CONSTRUCTION PLANS
FOR
THE RIDGE AT LORSON RANCH FILING NO. 2

STREET & STORM SEWER CONSTRUCTION PLANS

SF 22-005

**THE RIDGE AT LORSON RANCH FIL NO. 2
STREET & STORM SEWER
CONSTRUCTION PLANS**

STREET / STORM - NORTH AREA
WALLEYE DRIVE
 STA 31+98 TO 38+50

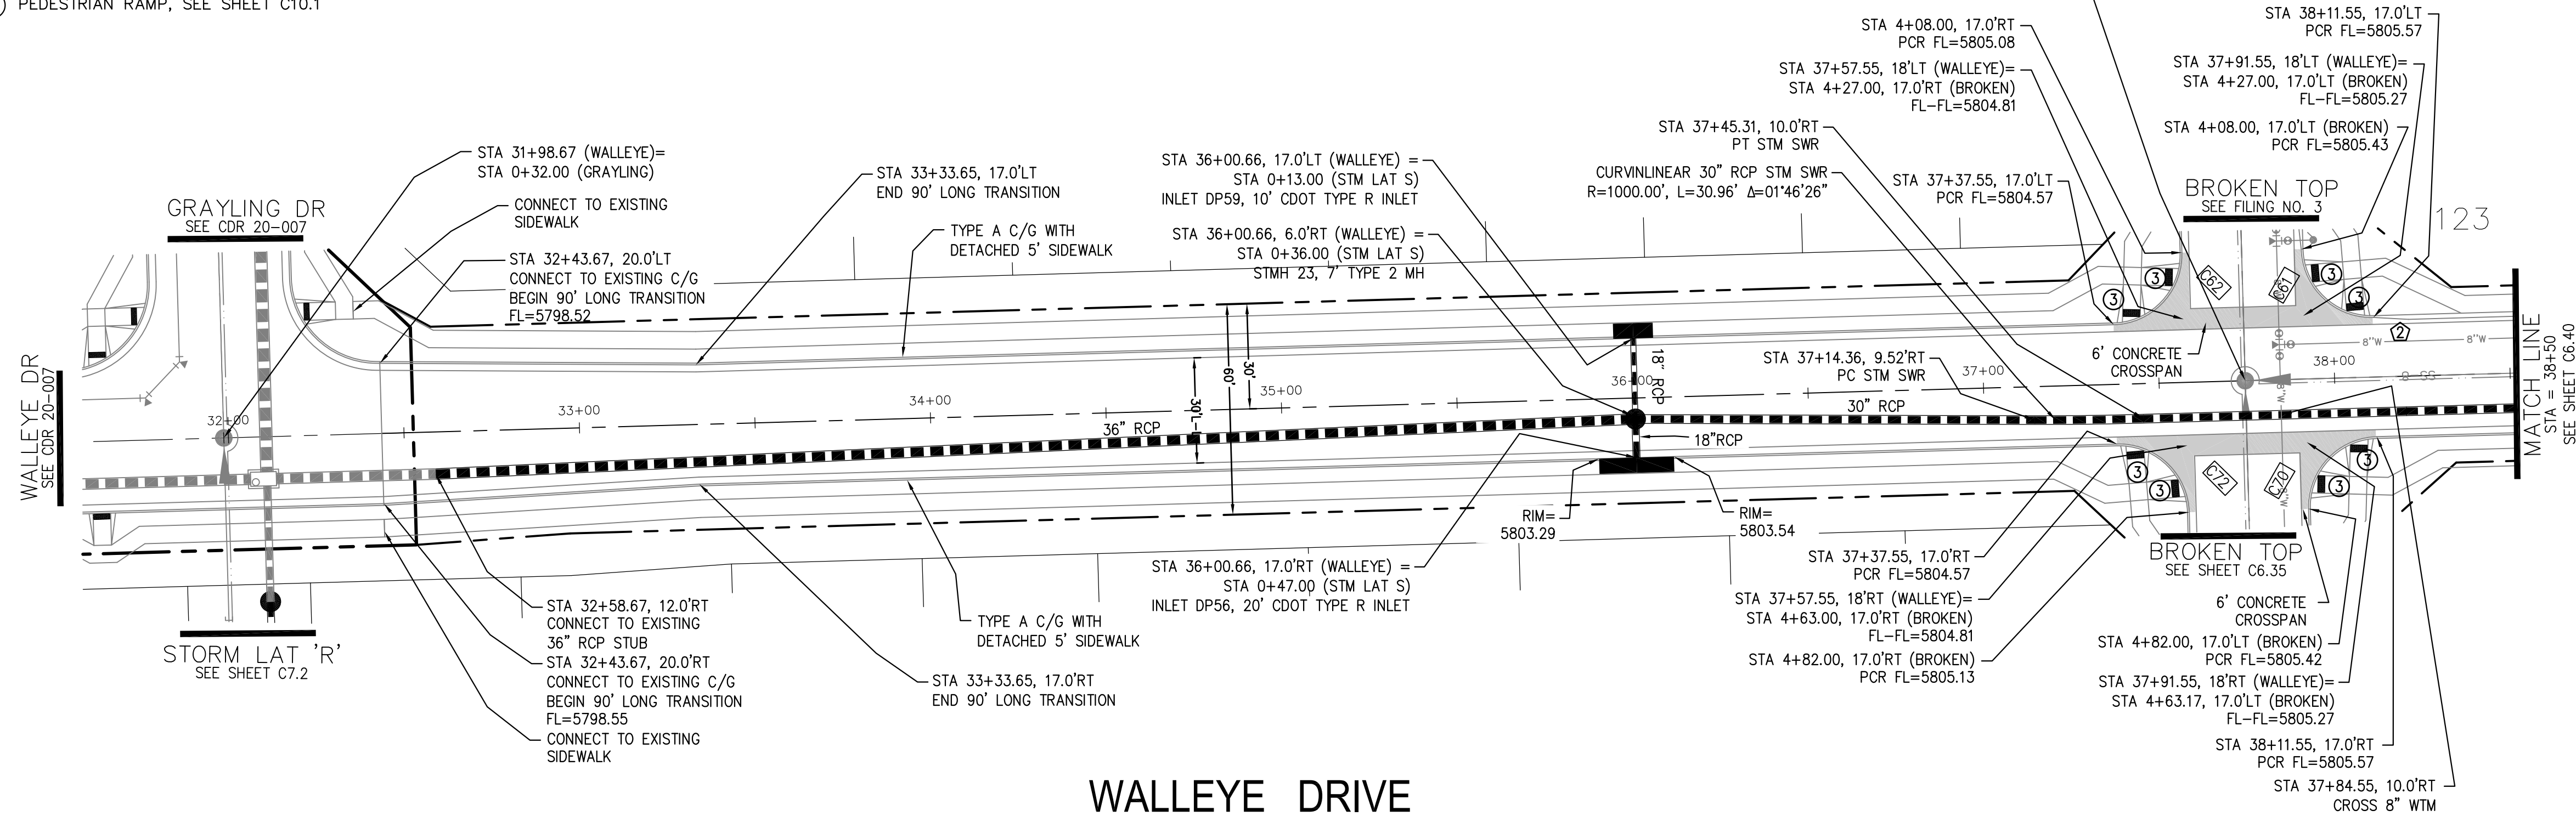
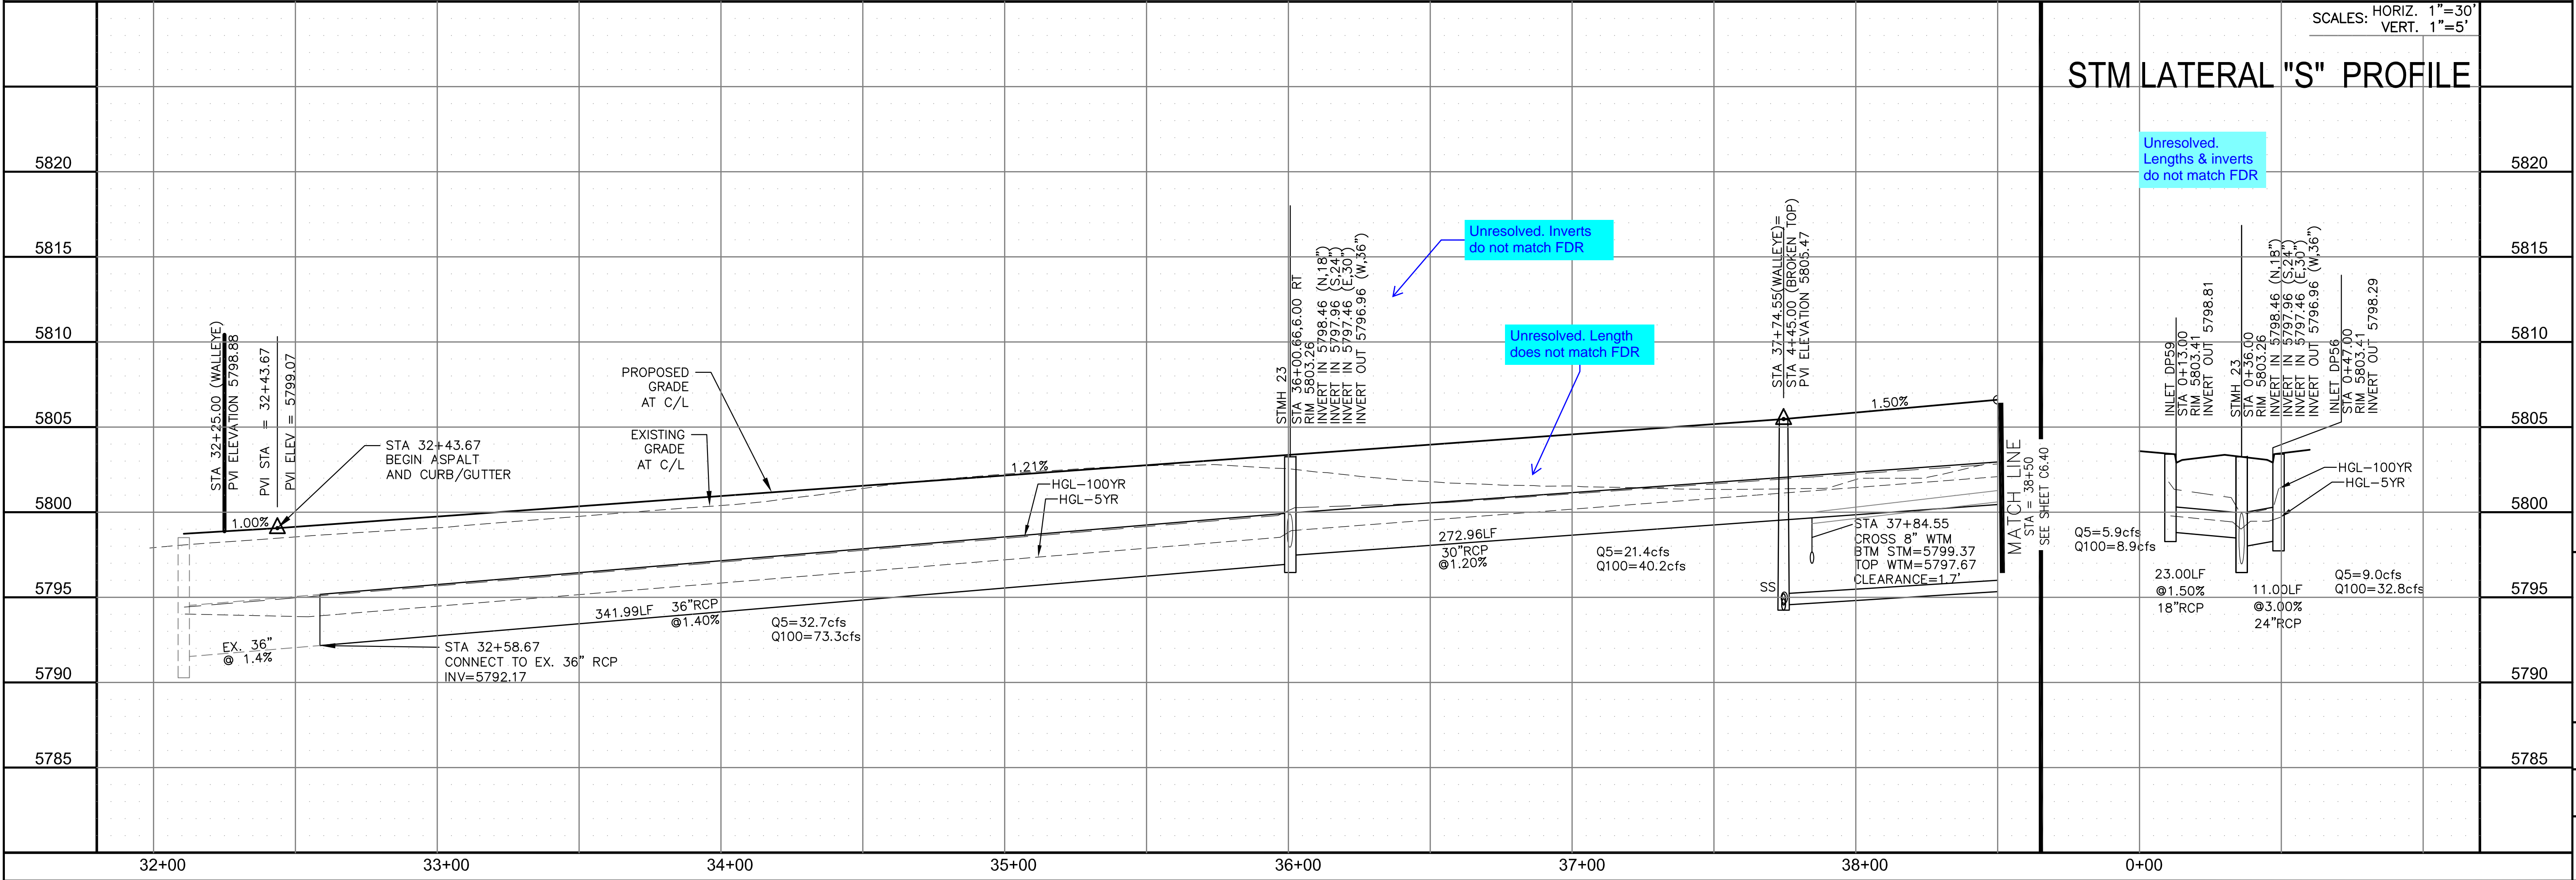
Unresolved. Show all lot numbers.

Unresolved. Lengths & inverts do not match FDR

Unresolved. Inverts do not match FDR

Unresolved. Length does not match FDR

DONNAS DRIVE

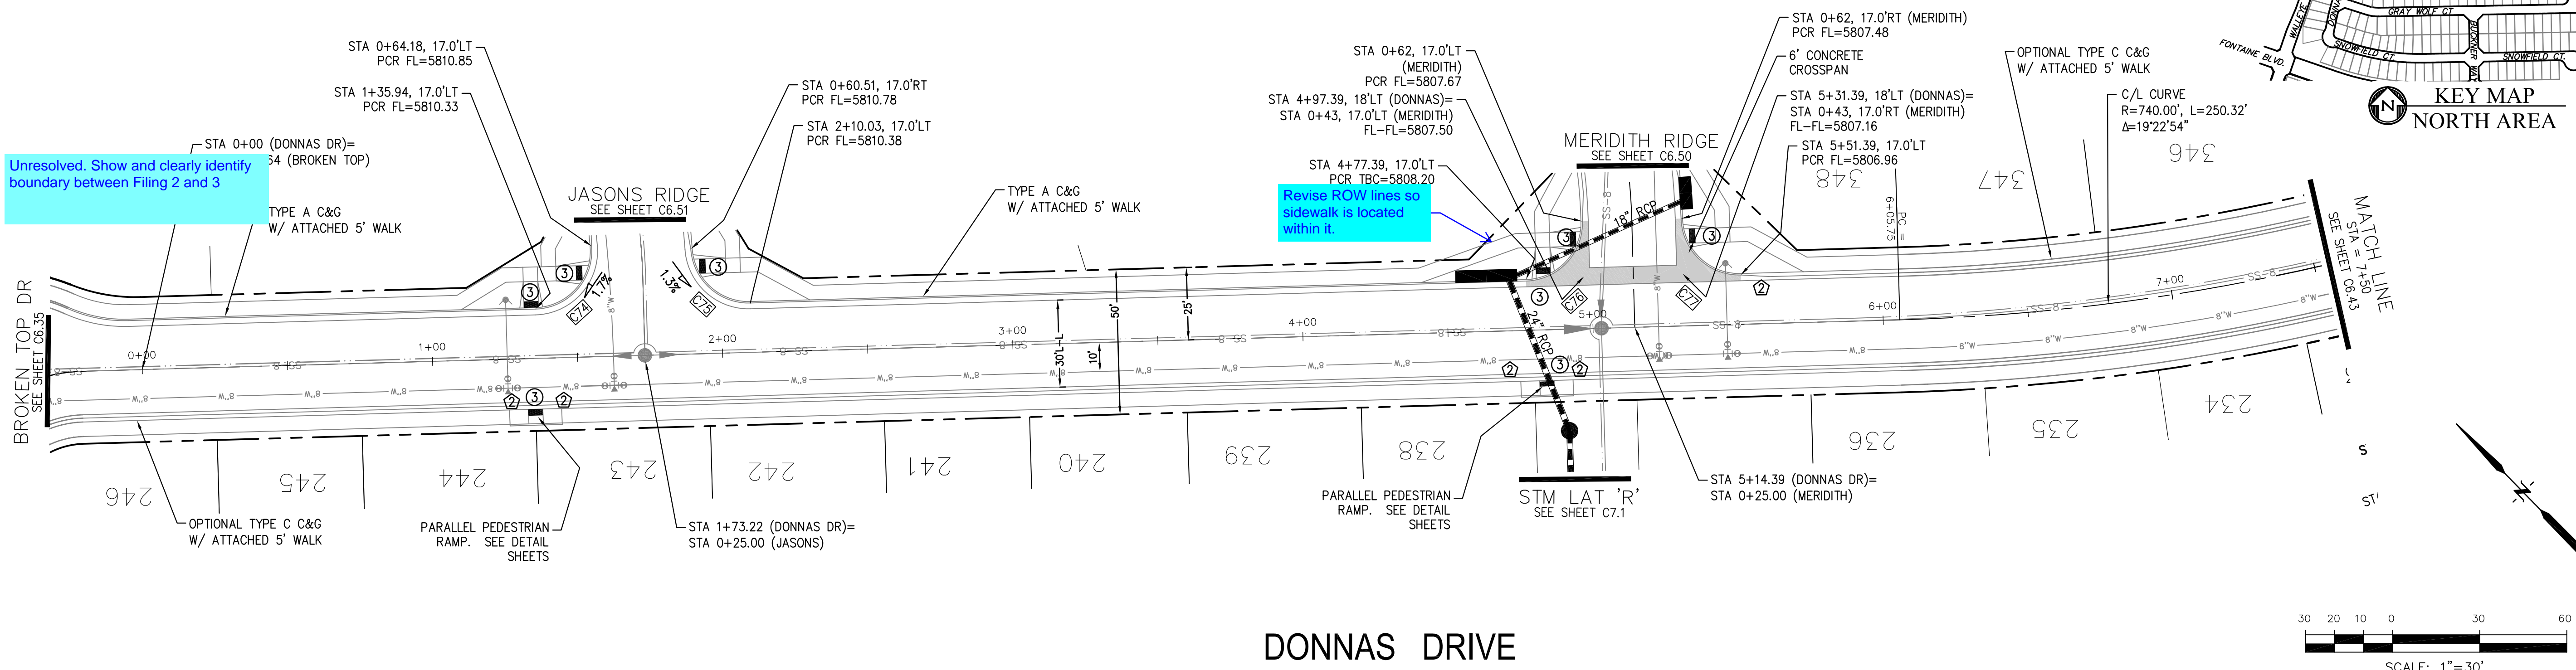
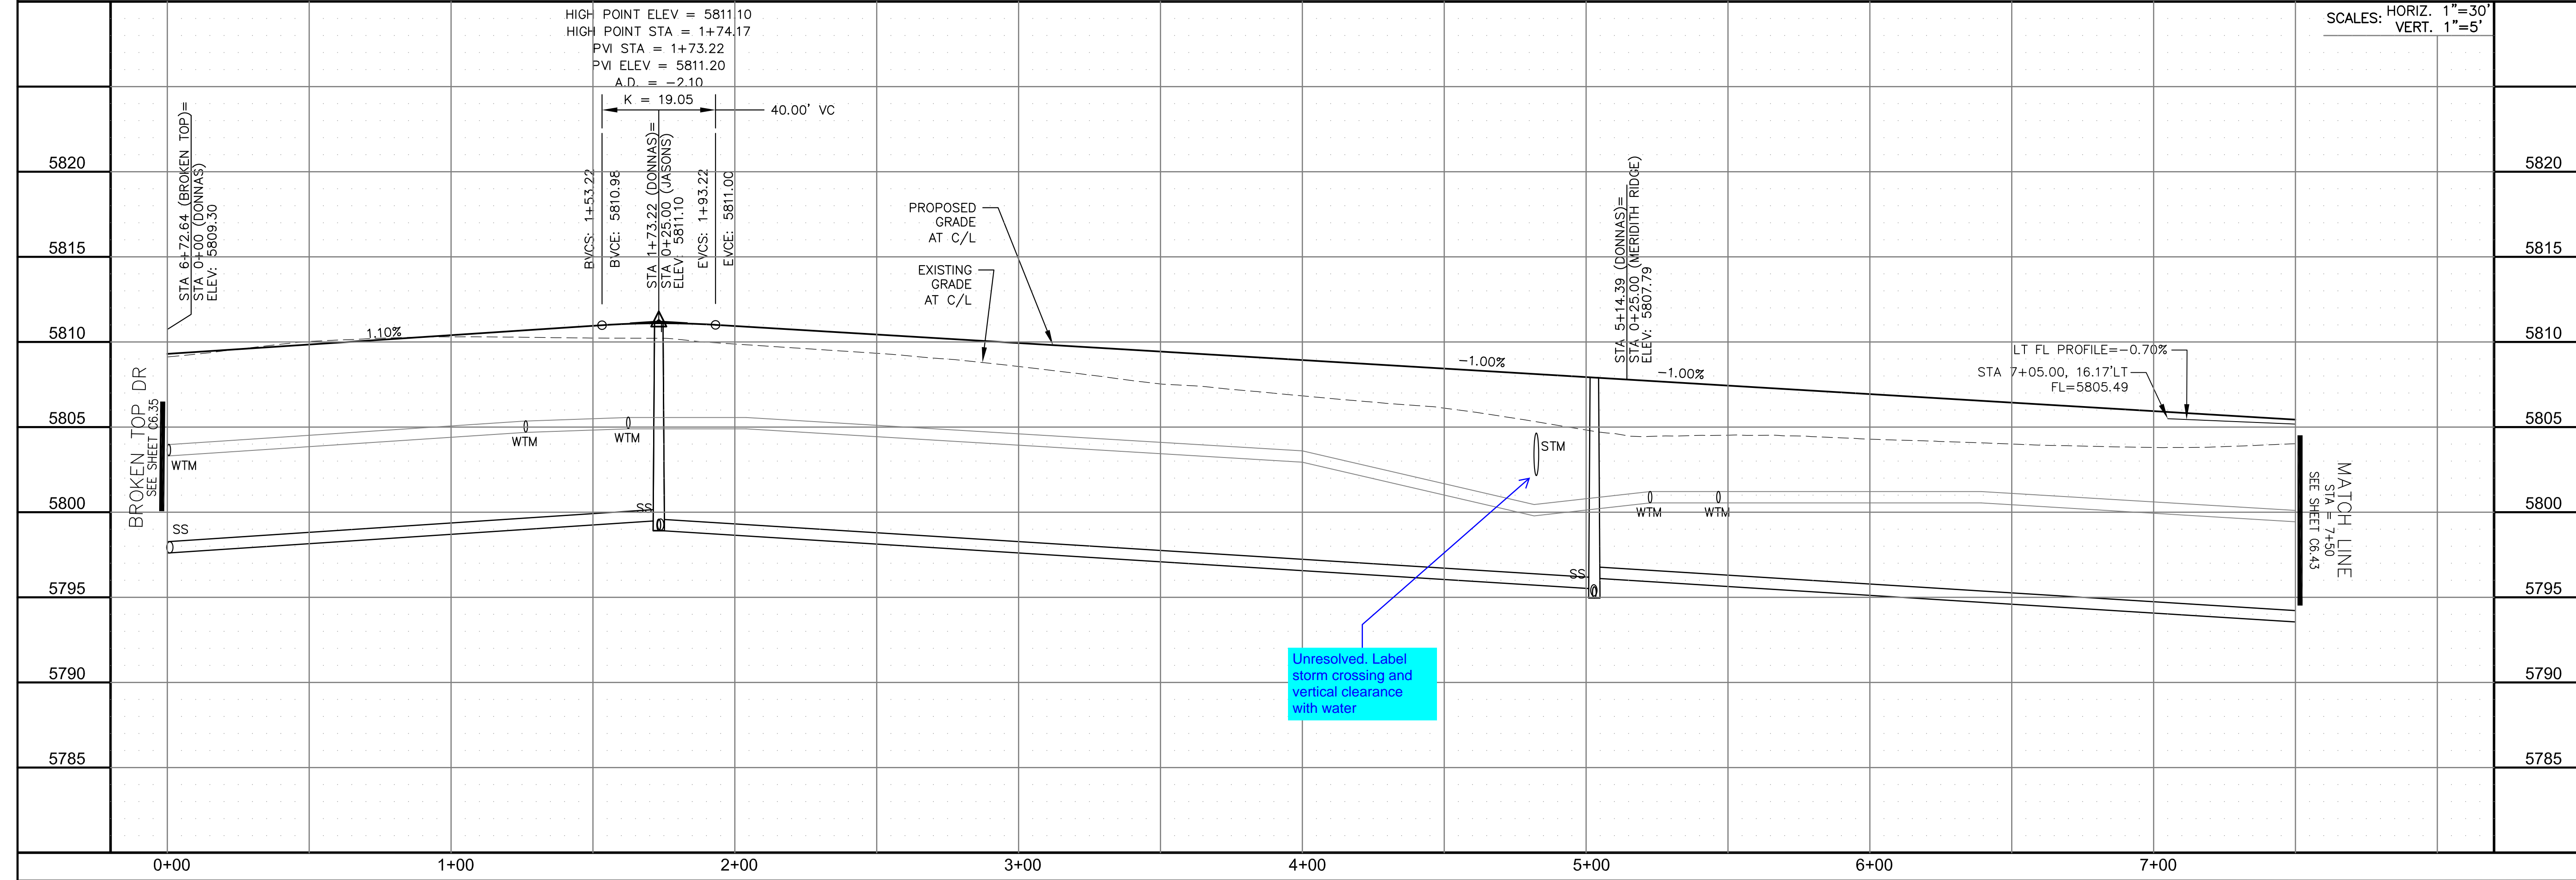
Unresolved. Show and clearly identify boundary between Filing 2 and 3

Revise ROW lines so sidewalk is located within it.
